**CERTIFICATE OF APPROPRIATENESS**

**Property:** 1212 Tulane Street, Lot 27, Block 183, Houston Heights Subdivision. The property includes a historic 1,580 square foot, 1½-story wood frame single-family residence situated on a 4,400 square foot (33' x 132') interior lot.

**Proposal:** Alteration – Revision. The applicant was granted a COA in January 2015 for a rear two-story 1,621 square foot addition beginning at the rear wall of the historic house. All existing original 1-over-1 wood windows and original 117 wood siding were to be retained and repaired.

**Recommendation:** Approval with conditions:

WEST ELEVATION – FRONT FACING TULANE STREET

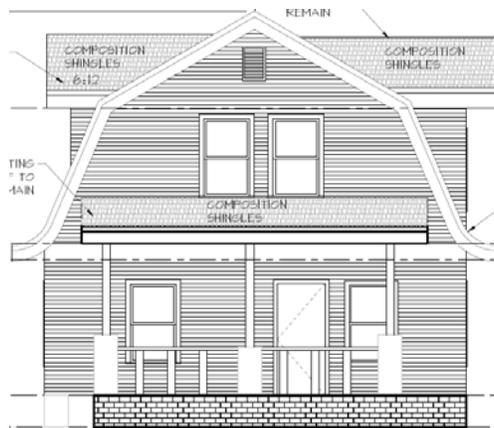
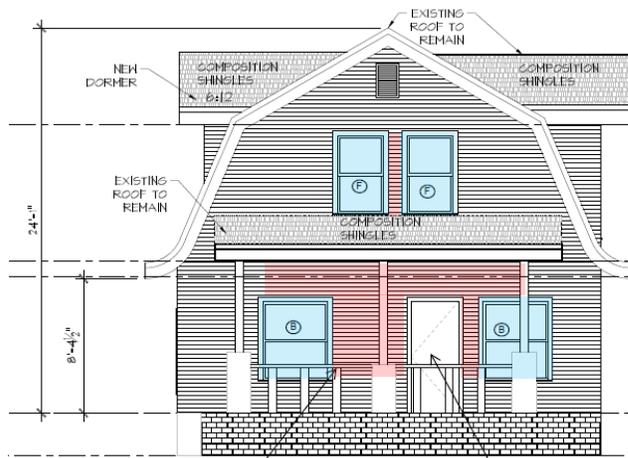
June 2015: The applicant has exceeded the approved scope of work. Significant portions of the original siding have been removed and replaced, especially on the first story. All trim has been removed. All original windows have been removed and replaced with flange mounted vinyl windows. The two front windows were also reduced in width. The original portion of the house was raised 8" separating the porch roof from the columns (which are now topped by blocking). See drawings and photos for more detail.

**NORTH SIDE ELEVATION**

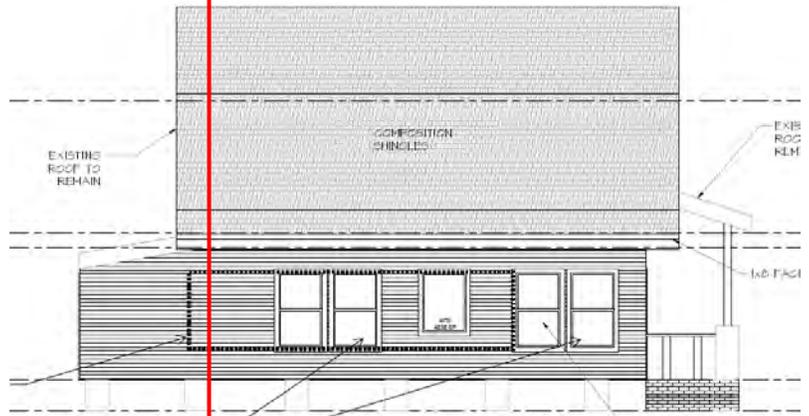
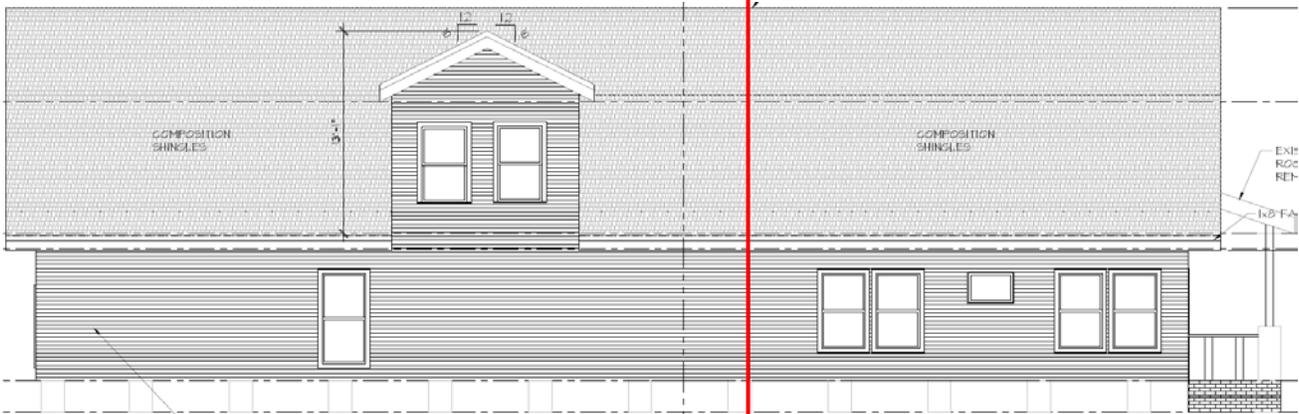
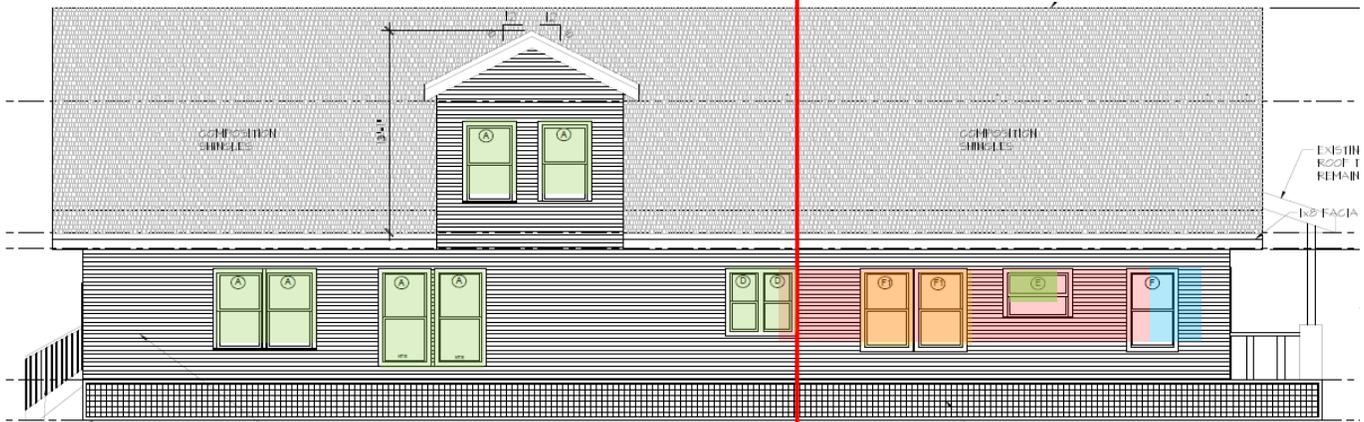
June 2015: The applicant has exceeded the approved scope of work. The original portion of the house was raised 8" separating the porch roof from the columns (which are now topped by blocking). Significant portions of the original siding have been removed and replaced. All original windows have been removed and replaced with flange mounted vinyl windows. The westernmost pair of windows has also been significantly altered. The western window of this pair has been shifted to the west while the eastern window has been removed altogether. The addition now has three pairs of windows, five more windows than originally approved. See drawings and photos for more detail.

**SOUTH SIDE ELEVATION**

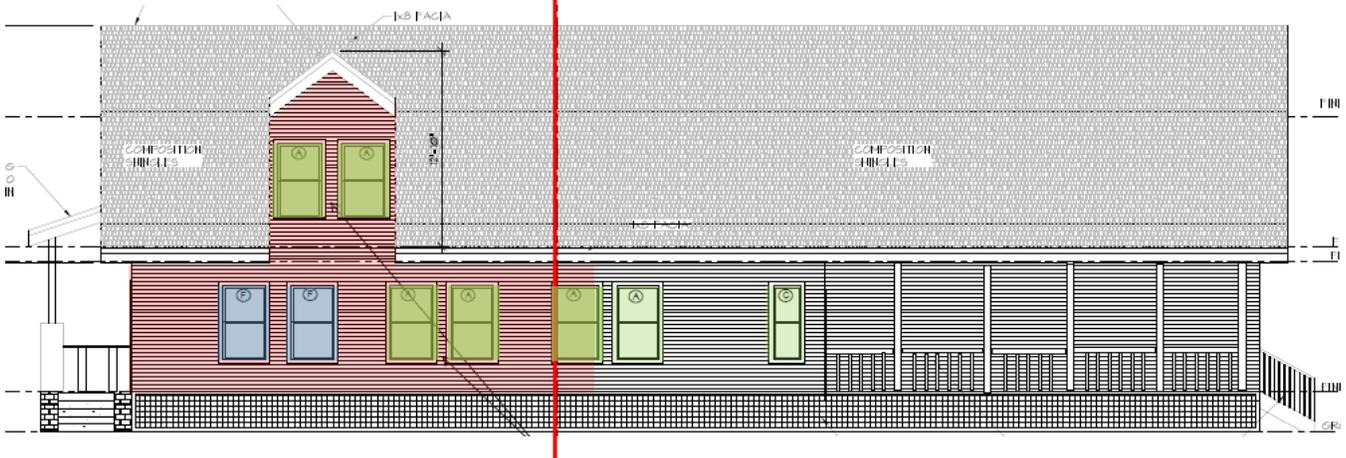
June 2015: The applicant has exceeded the approved scope of work. The original portion of the house was raised 8" separating the porch roof from the columns (which are now topped by blocking). All original siding has been removed and replaced. All original windows have been removed and replaced with flange mounted vinyl windows. The addition now includes two more windows than originally approved. The rear inset portion is now a porch with five columns and a railing system. The proposed additional dormer was never constructed. See drawings and photos for more detail.
